WEEKS MARINE INC.**WMI Job No. 2010-0148****REQUEST FOR INFORMATION (RFI) NO. 002****CONTRACT NO. B000964.001**

ARCADIS RFI number: 003,
Weeks RFI No 002

SECTIONS
SHEET 2 OF 3
STRUCTURAL

Reference: S-17 Details 5

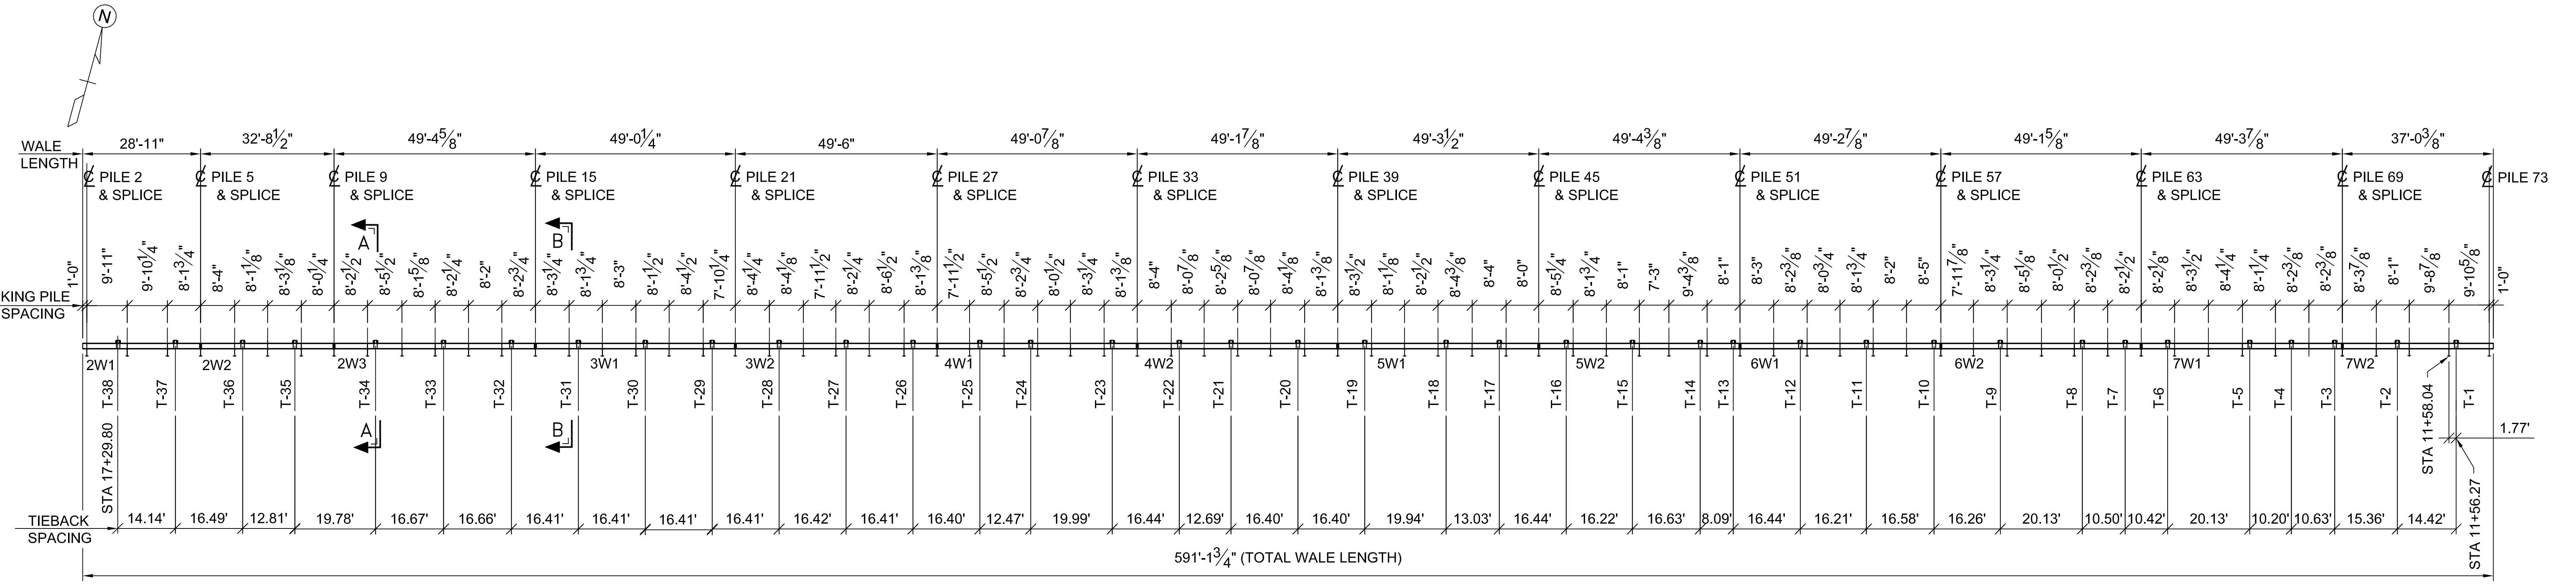
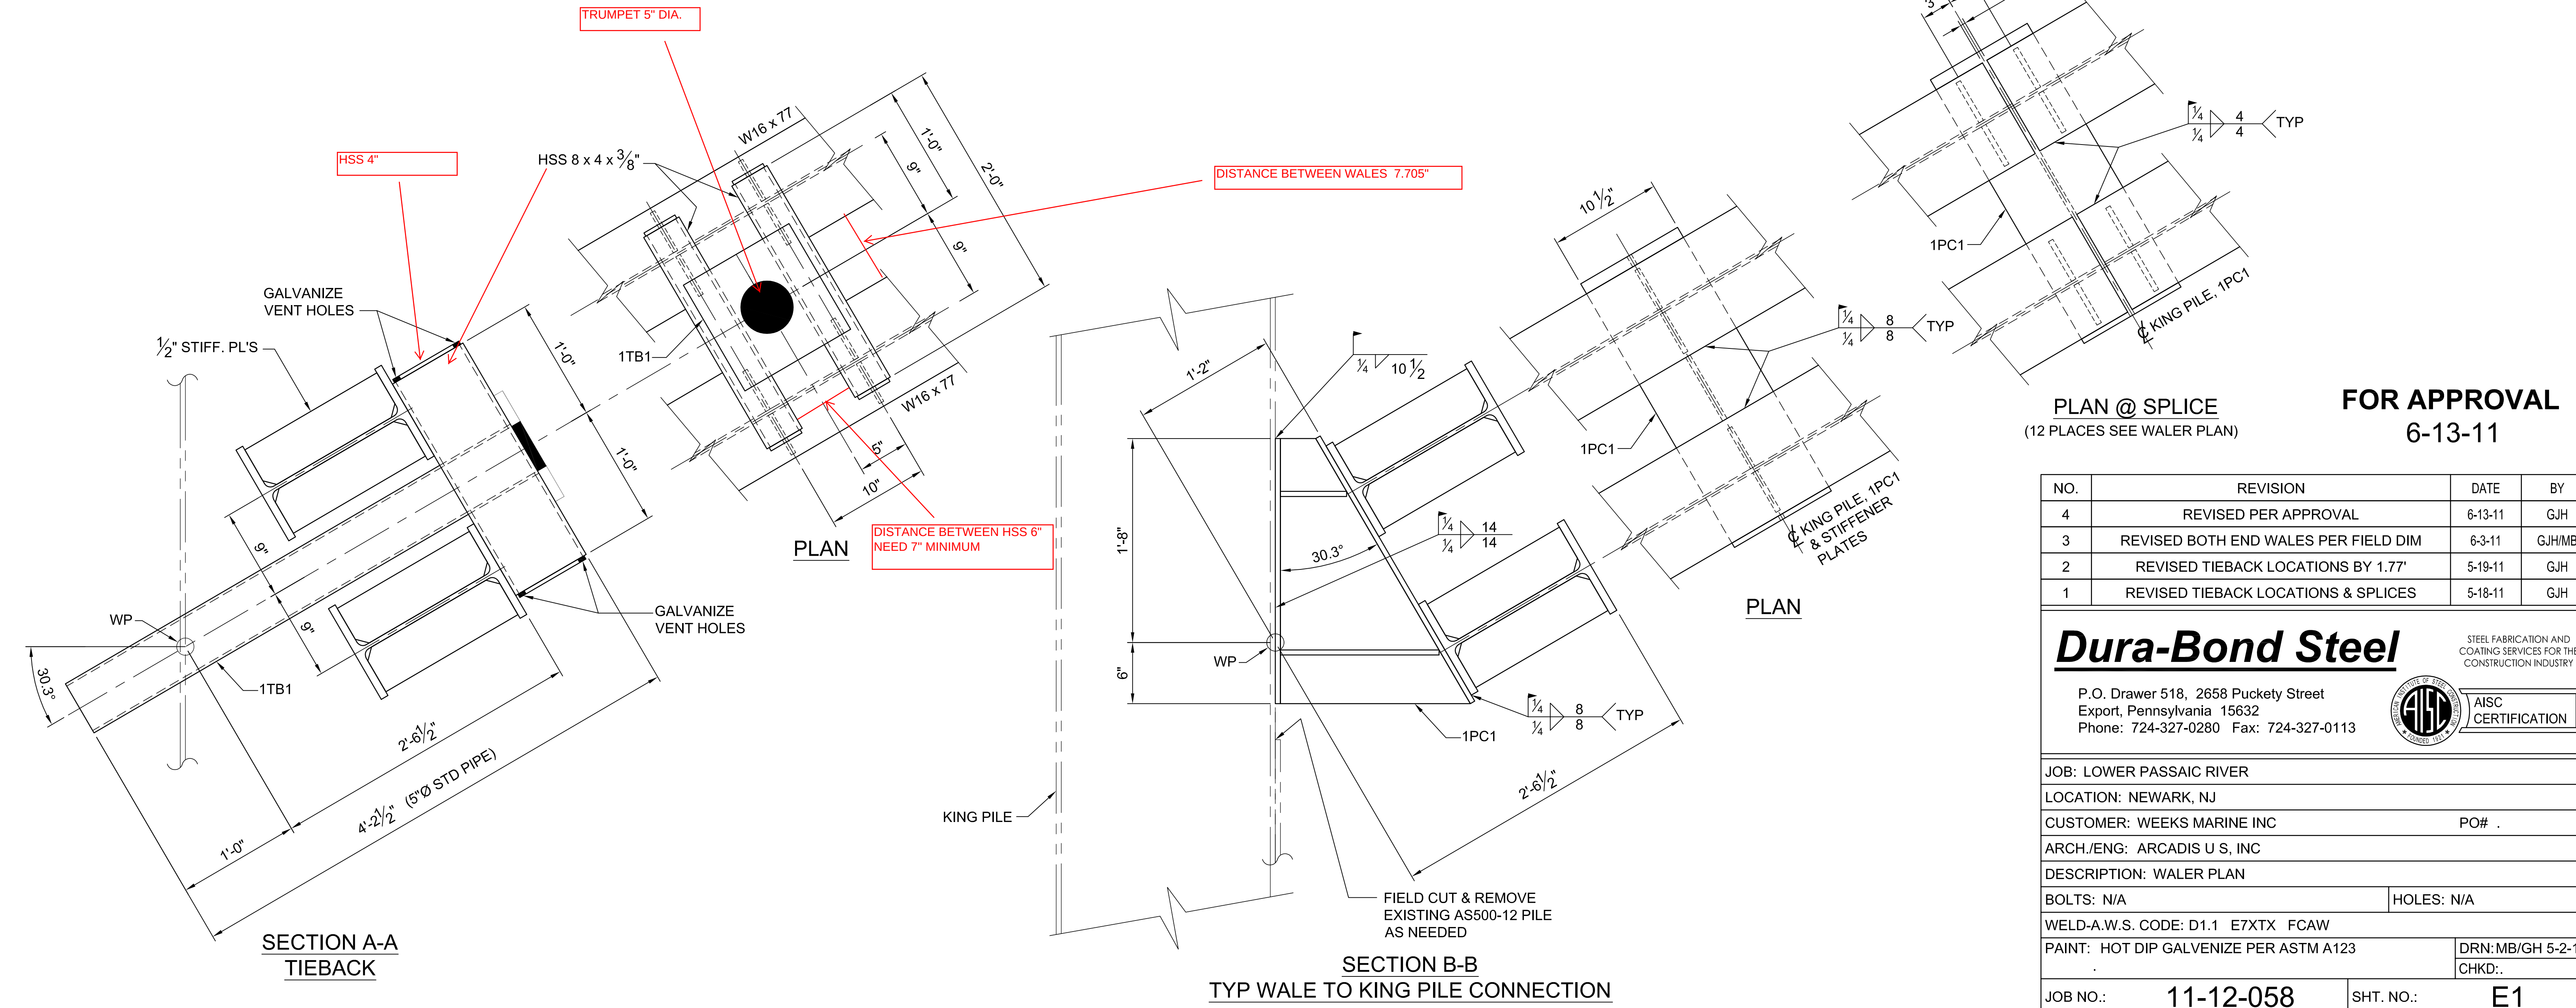
The detail 5 shows the 2 HSS 8x4x3/8 being 6" apart. Since the HSS will be installed prior the drilling occurs the spacing between the HSS must be at a minimum of 7" to allow the drill (6-1/2" dia.) to get between the HSS. Please confirm that the HSS could be moved accordingly.

The HSS 8x4 members may be moved apart to provide 7" clearance between the faces of the tubes. This shift may occur without moving the Full Height Stiffeners.

Reference: S-5 Detail 6

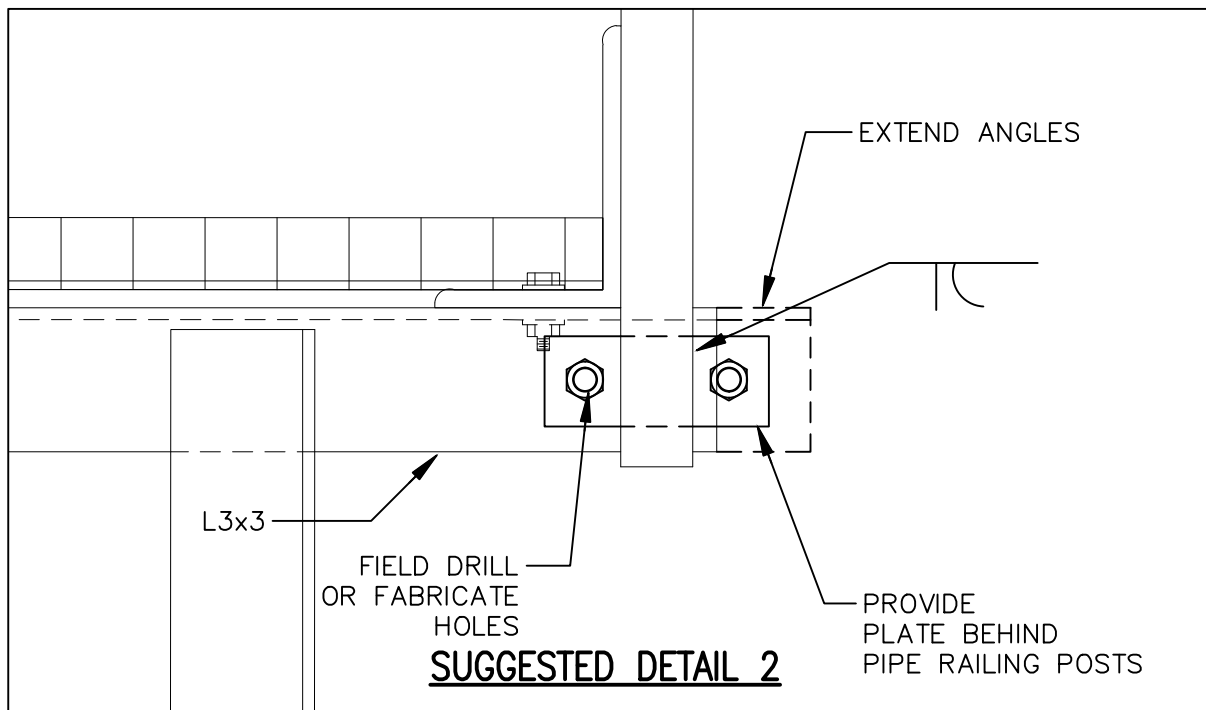
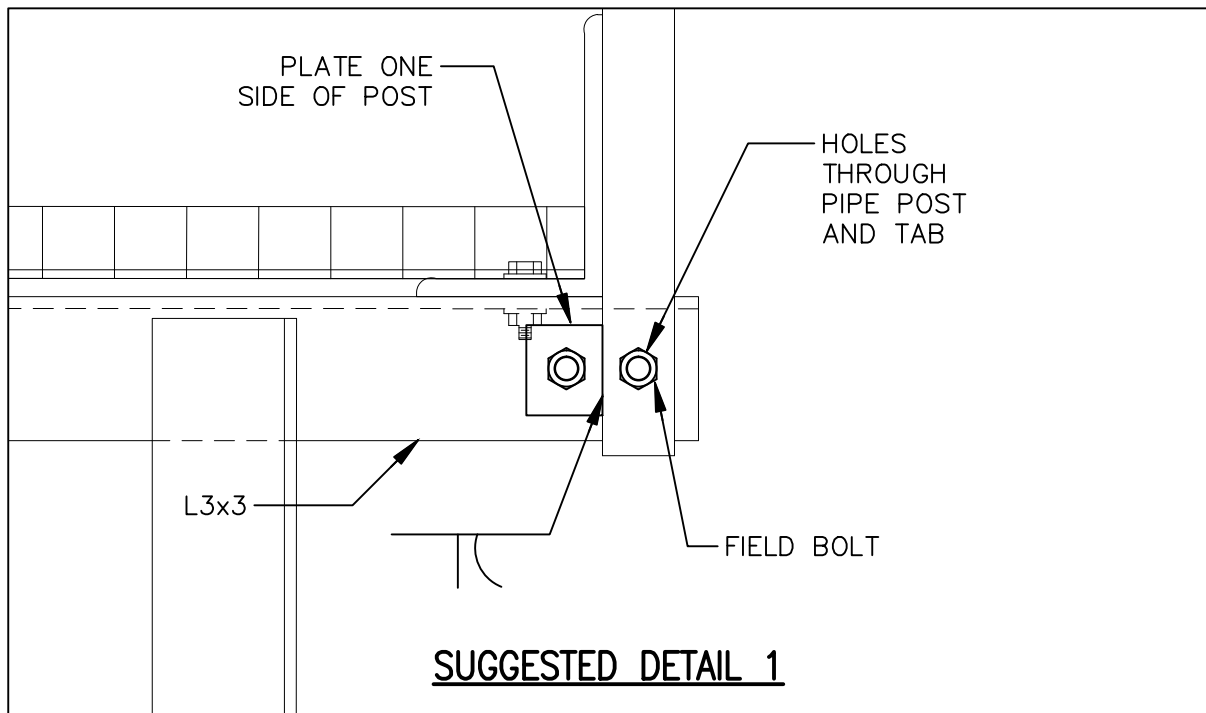
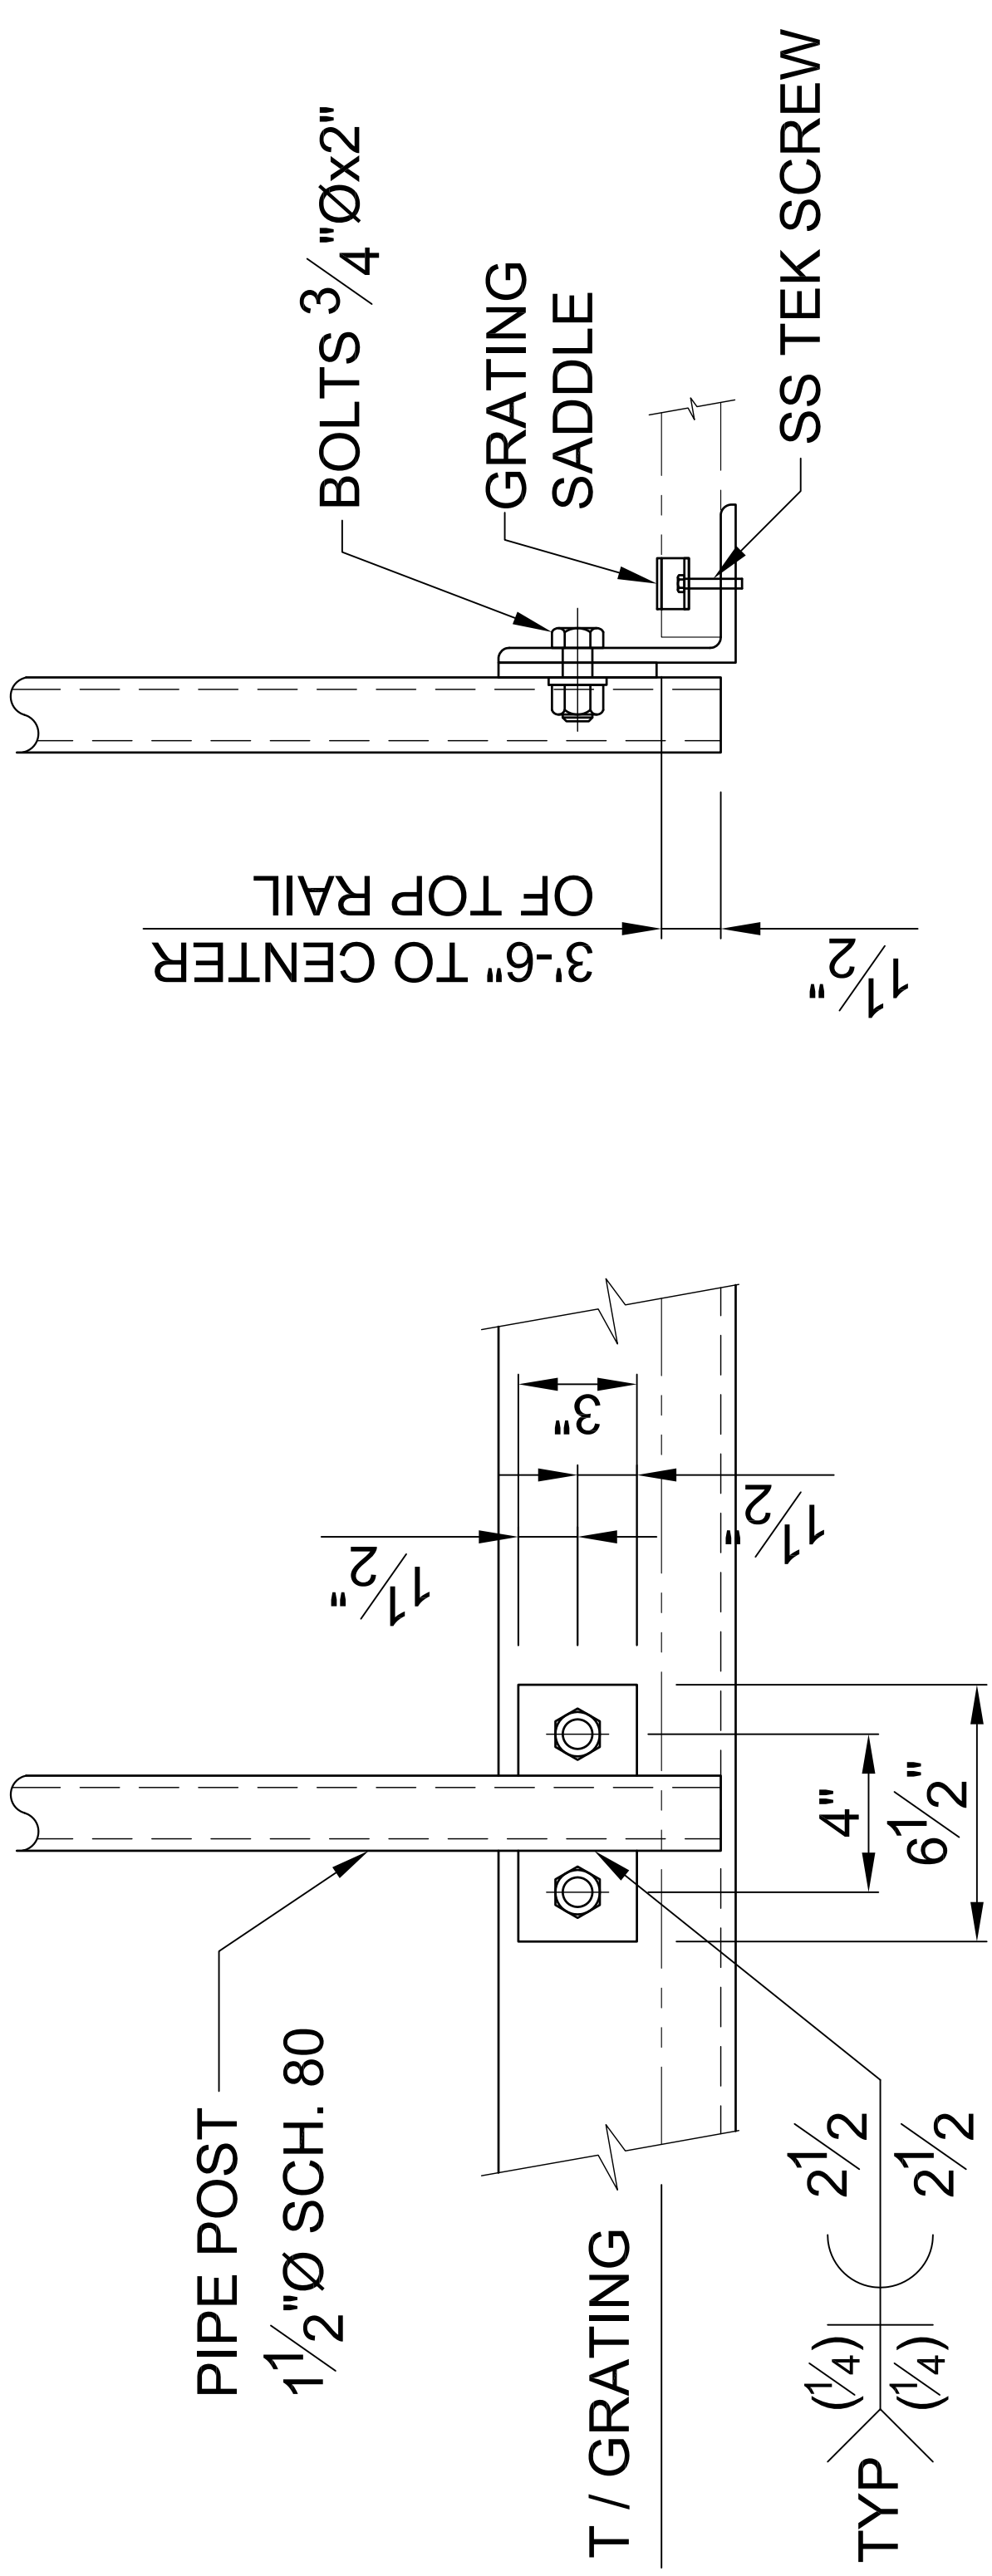
- 1.The steel post connection shown on drawing S-5 Detail 6 is welded to the 3x3 angle and 6x4x3/8 angle.
- 2.The grating connection shown on drawing S-5 Detail 6 is welded to the 6x4x3/8 angle.

These connections need to be done prior the galvanization and installation. As you are aware the handrail and other parts of the walkway will bend during the galvanization process and damages will occur during transport and installation.

- 1.Steel posts will be welded to a plate (6-1/2x3x)
- 2.The plate will be bolted to the 6x4x3/8 angle in the field.
- 3.The grating will be bolted to the 6x4x3/8 angle using SS tek screw, which is standard practice for grating.

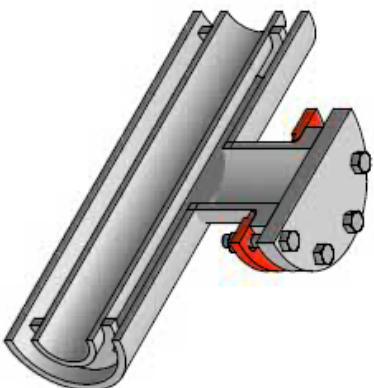
The 12" pipe stop where the vacuum breaker and flexible joint will be installed.

This section shows a typical connection to the 12" dia. pipe only. It doesn't reach the 8" dia.

The contract drawings required flexible connection at the enclosure and the UPF area. Weeks has discussed with Isco to provide a flexible connection with double containment pipe. The manufacturer has stated that the flexible connection is only for the carrier pipe (8" dia. pipe) and has not for the containment pipe (12" dia. pipe) Attached is the cut sheet of the 8" dia. flexible connection. Please confirm that Weeks will install the flexible connection as shown.

Thanks for your response. This approach looks fine, as long as we find a solution for secondary containment around the flexible section. I understand from Matt Bowman that you will be working through that solution once you guys get some of the more time-critical items off your plate.
